Detailed Site Plan Departure from Design Standards Alternative Compliance Flats at Glenridge Station

DSP-23008
DDS-24002
AC-24005

STAFF REPORT

SUBJECT: Detailed Site Plan DSP-23008
Departure from Design Standards DDS-24002
Alternative Compliance AC-24005
Type 2 Tree Conservation Plan TCP2-001-2025
Flats at Glenridge Station

Figure 1: Site Plan

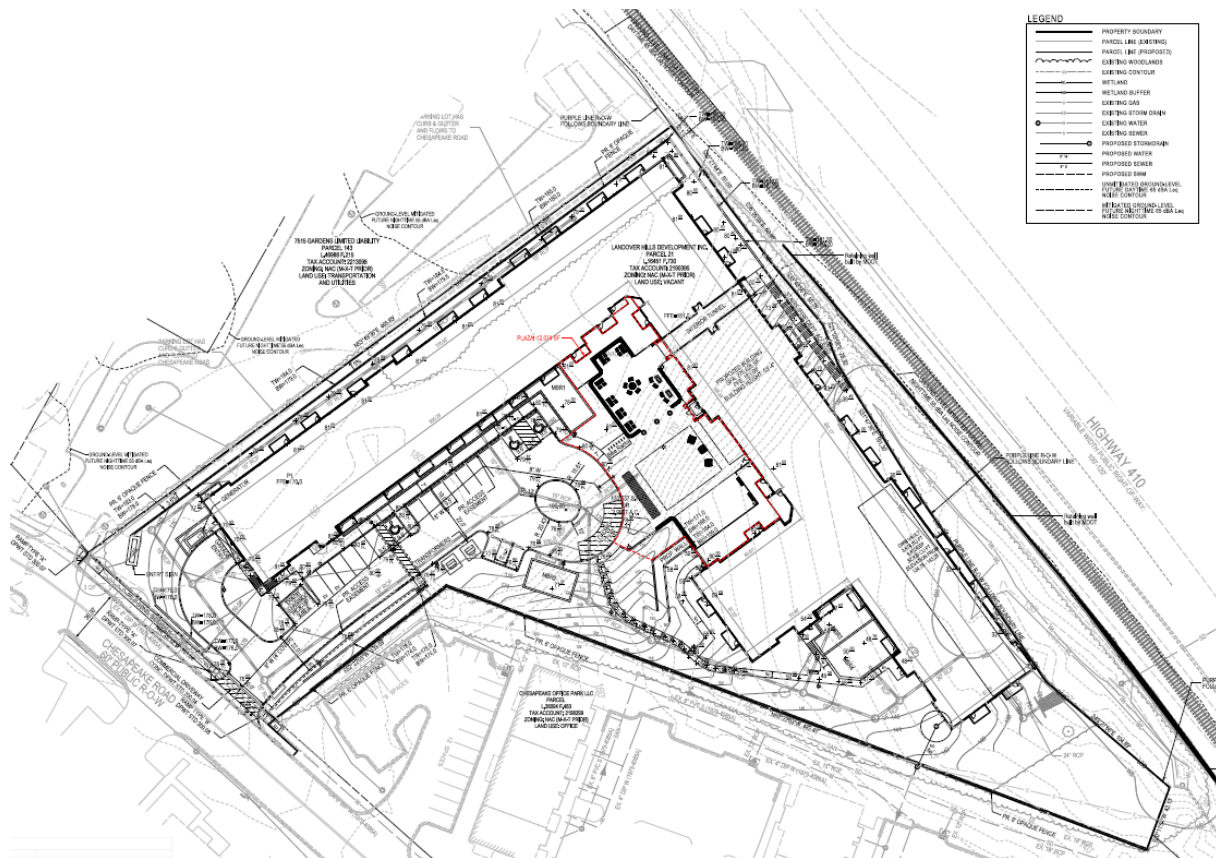
Notes: *Among 337 proposed parking spaces, 317 are located in the parking structure and 20 surface parking spaces are located in front of the proposed building. The floor plan for the parking structure, submitted with this DSP, does not include dimensions of drive aisles and parking spaces. A condition is included herein requiring the applicant to show all dimensions of drive aisles and parking spaces on the floor plan of the parking structure.

**The size of compact parking spaces, shown on the plan, is 8 feet by 16 feet. A condition is included herein requiring the applicant to correct the size of compact parking spaces to be 8 feet by 16.5 feet.

***Pursuant to Section 27-566 of the prior Zoning Ordinance, among 337 parking spaces provided, eight spaces need to be handicap-accessible. According to the Americans with Disabilities Act (ADA) requirements, among eight spaces, two need to be handicap van-accessible parking spaces. A condition is included herein requiring the applicant to indicate these two required handicap van-accessible parking spaces, with dimensions, on the plan and add this number to the parking schedule on the coversheet. In addition, the size of the handicap-accessible parking spaces, shown on the coversheet, is 9 feet by 18 feet, for which a condition is included herein requiring the applicant to correct it to be 9 feet by 19 feet.

Figure 5: Detailed Plan for Central Plaza

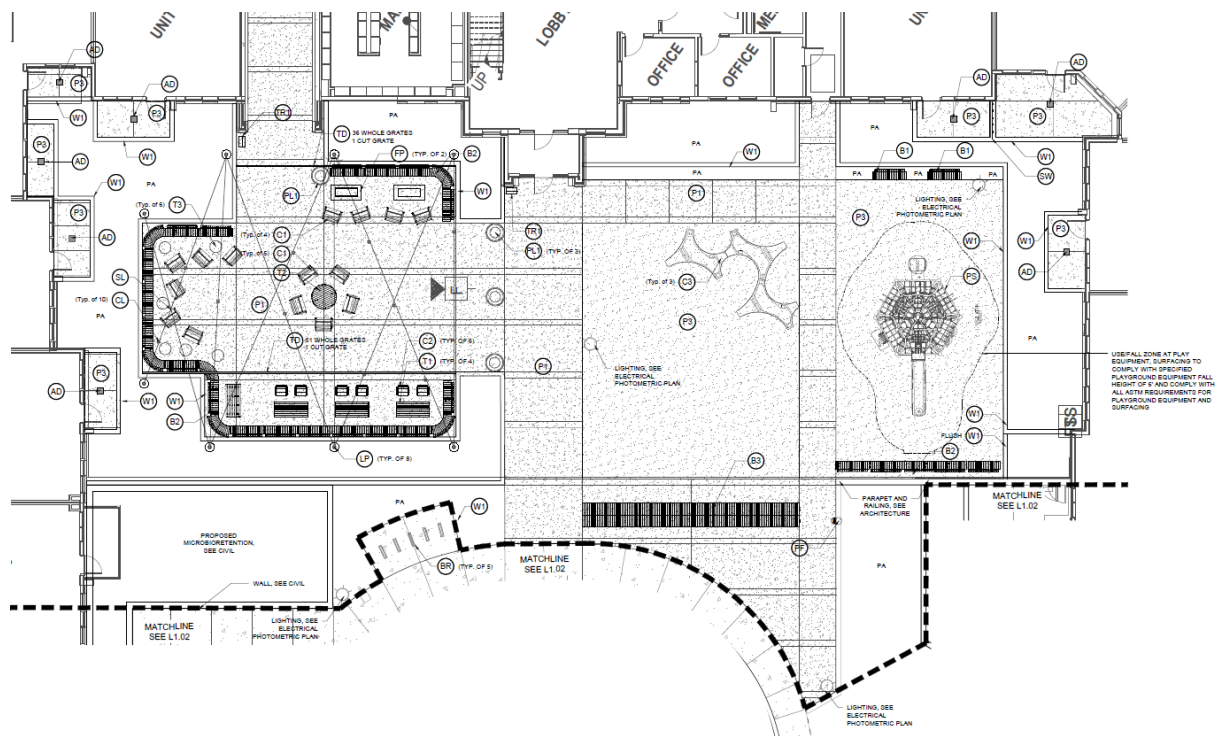
In this DSP, the applicant includes an open-air central plaza, of approximately 12,074 square feet, which complies with the minimum size of 80 feet by 100 feet. This plaza is open to the sky and oriented southwest, in order to bring in sunlight. The plaza is designed to reflect a high degree of urban design and encourages a variety of social activities, such as walking, and sitting in a pleasant public space. The plaza not only contains extensive landscaping around its perimeter, but also provides a range of seating options, trash receptacles, and a playground structure. One bench, which is located in the artificial turf area and next to the playground area, is designed in an artistic, sculptural form, to bring attractiveness and interest to the plaza. Staff find that this satisfies the requirement to provide a work of art

Figure 6: Relationship between Building, Purple Line and MD 410

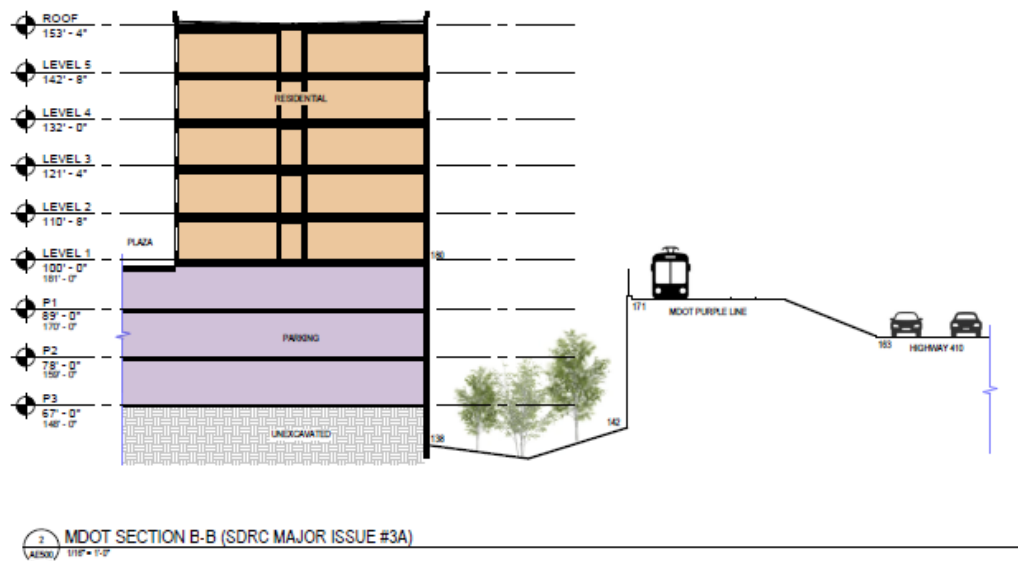
The required 50-foot-wide buffer, with plants, will likely be provided by the existing vegetation within the ROW of MD 410, which separates the proposed building from the Purple Line tracks. The subject DSP concentrates density in a mixed-use building on a property near a transit station. This approach will not overcrowd the land and, instead, leave some area for open space to bring light and air to the property. In particular, the applicant proposes open space in the form of a plaza in front of the building.

The building cannot be moved away from MD 410 without shrinking the proposed central open space and creating a more disjointed open space system. Therefore, based on the property's shape and topography, to achieve the desirable density of this project and provide meaningful open space, a departure from the 50-foot-wide buffer is necessary.

Based on the analysis above, staff support Departure from Design Standards DDS-24002, for a departure to allow approximately 0.5 feet from the eastern property boundary along MD 410 and no plant materials, as a result of the unique shape of the property, along with the steep slope and retaining wall separating the property from the Purple Line tracks. As noted in the beginning of this finding and discussed in Finding 12 below, the applicant filed Alternative Compliance AC-24005 from the requirements of Section 4.6 of the Landscape Manual. The Planning Director denied this request because there is no feasible proposal that would exhibit equally effective design characteristics, as defined in the Landscape Manual.
